Title		
01.Revisions V2.0		
Size	Document Number	Rev.
A2	1	2.0
Date:	Wednesday, January 02, 2008	Sheet 1 of 18

Title		
4. LPC/BIOS/IDE		
Size	Document Number	Rev
A4	1	1.0
Date:	Wednesday, January 02, 2008	Sheet 4 of 18

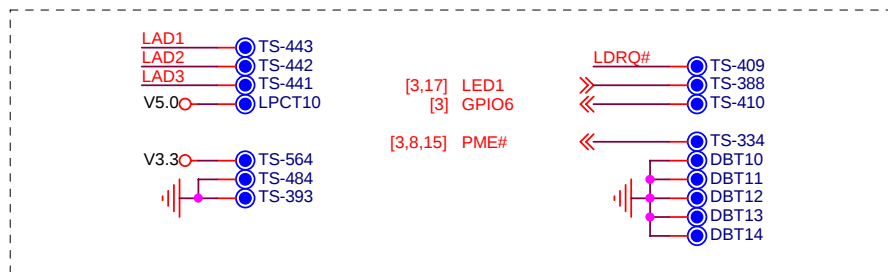
page11: change CN8 封装CON2_2.54MM_DIP_B;
page17: change J5 pin1 net PWRK_KEY;
page17 : change 螺丝孔接地网络CHASSIS;
page7 : change CN6 封装CON6_1.0MM_RX;
page12: change J7 封装FPC-26-SMT-LI;
page4 : J14 add pin45 pin46 到GND

page4 : J14 add pin45 pin46 到GND
page12: U24 pin117、pin64 脚网络对调

page04 : IDE接口网络 A1与A0互换;

Title			
6. USB			
Size	Document Number		Rev
A4	1		1.0
Date:	Wednesday, January 02, 2008		Sheet 6 of 18

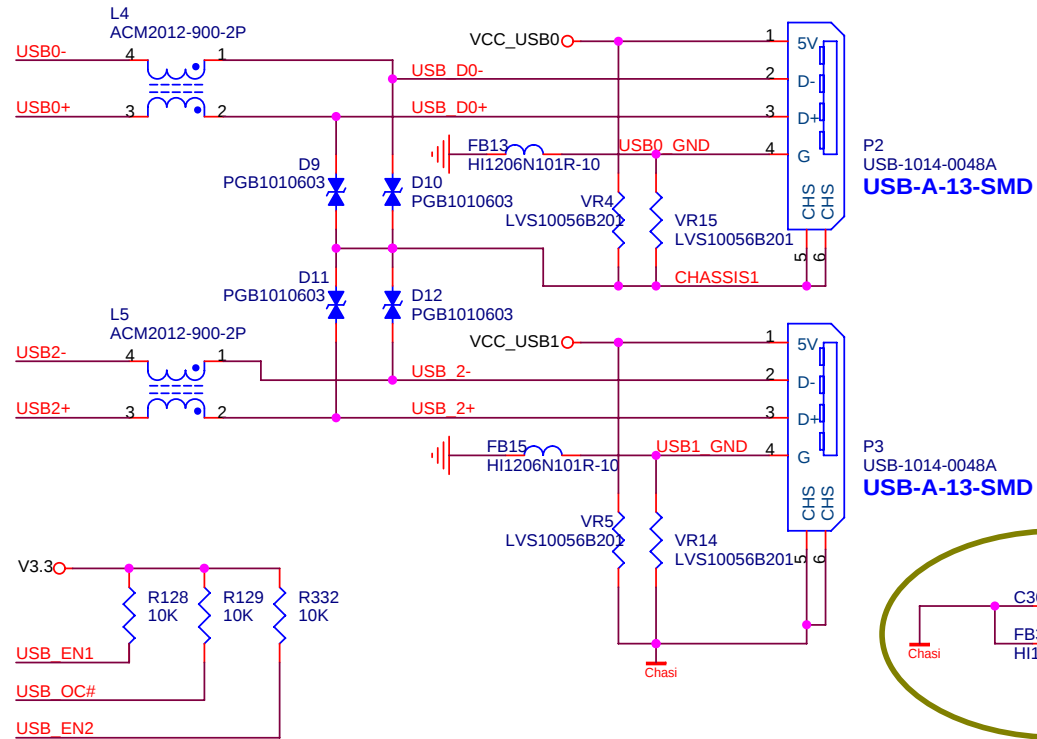
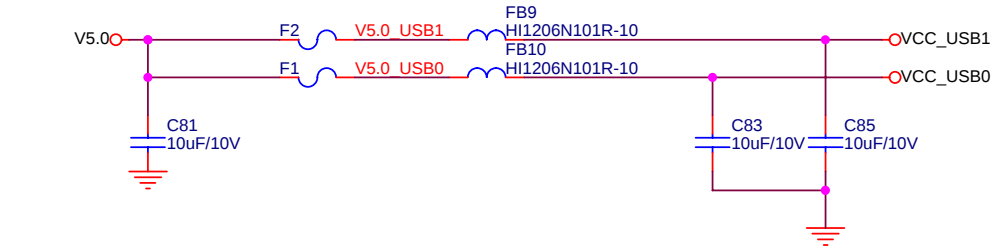
page6 : add C362, FB34 ;
page11: add C363, FB35 ;

Title		
17. LED		
Size A4	Document Number 1	Rev 1.0
Date:	Wednesday, January 02, 2008	Sheet 17 of 18

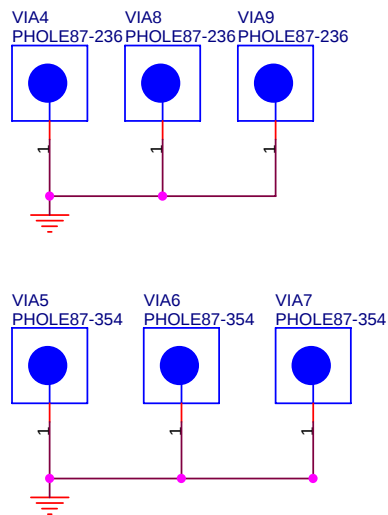
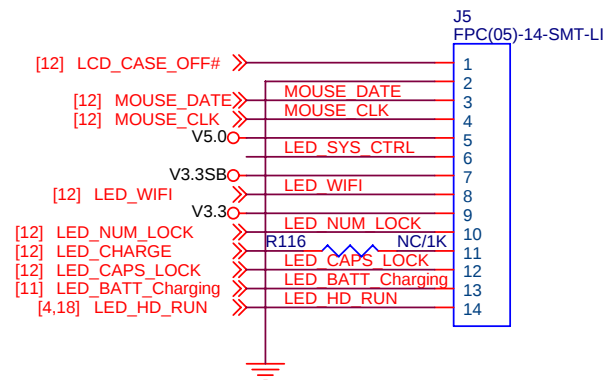
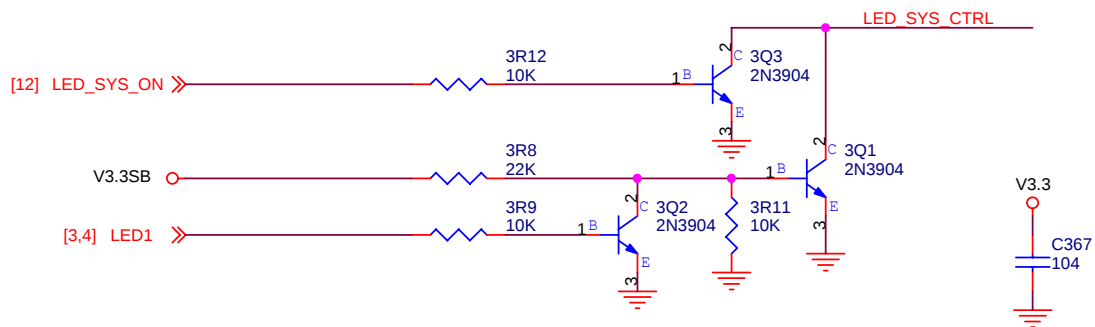
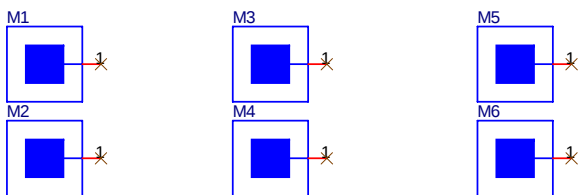
page17: add Hall Switch;
page11: J6 change footprint BATCON9_T2.5_DIP;
page2 : 所有排阻镜像, 方便布板;
page17: add 8个螺丝孔;

page17: add 6个MARK点;
page3: SMB_SDA_1与SMB_SCL_1短路
将其分开;
